**Collective amendments – Regulations Nos. 6, 7 and 48**

### **Proposal for Supplement 22 to the 01 series of amendments to Regulation No. 6 (Direction indicators)**

#### **Submitted by the experts from the Working Party “Brussels 1952”\***

*On and above the H plane for all lamps.*

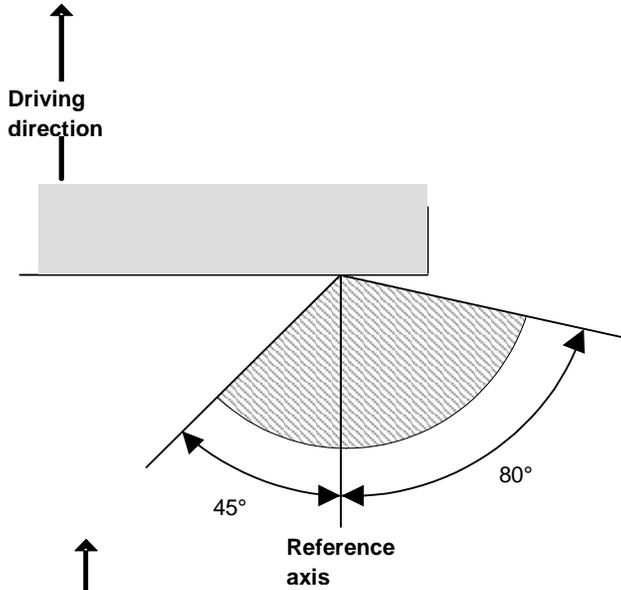
The text reproduced below was prepared by the expert from the Working Party “Brussels 1952” (GTB) in order to introduce, into Regulation No. 6, revised requirements concerning the inboard geometric visibility angles related to devices mounted on the rear of the vehicle. The modifications to the existing text of the Regulation are marked in bold for new or strikethrough for deleted characters.

Annex 1, amend to read:

*Under the H plane for lamps intended for M<sub>2</sub>, M<sub>3</sub> or N<sub>2</sub> category of vehicles.*

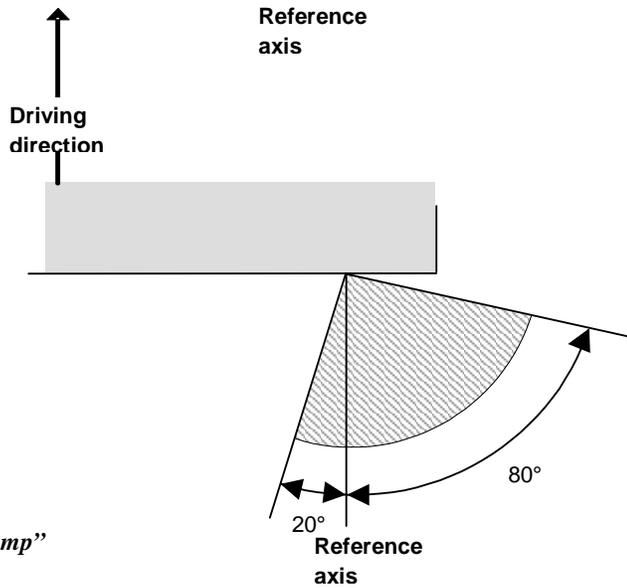
2. Although priority was given to the lamps on the front of the vehicle, there is a similar problem to achieve the inboard geometric visibility requirements at the rear of the vehicle where styling trends based on better aerodynamics lead to contoured shapes making the fulfilment of the 15 down and 45 inward visibility requirement impossible. In view of this, the GTB Signal lighting Working Group has carefully considered the safety implications of extending the reduction of the inboard visibility requirements when the stop lamp, direction indicator and position lamps are mounted below 750mm. The conclusion is that the same safety principles that were debated in GRE for the front mounted devices will also apply to rear mounted lamps with the condition that the angles are only reduced below the horizontal plane.
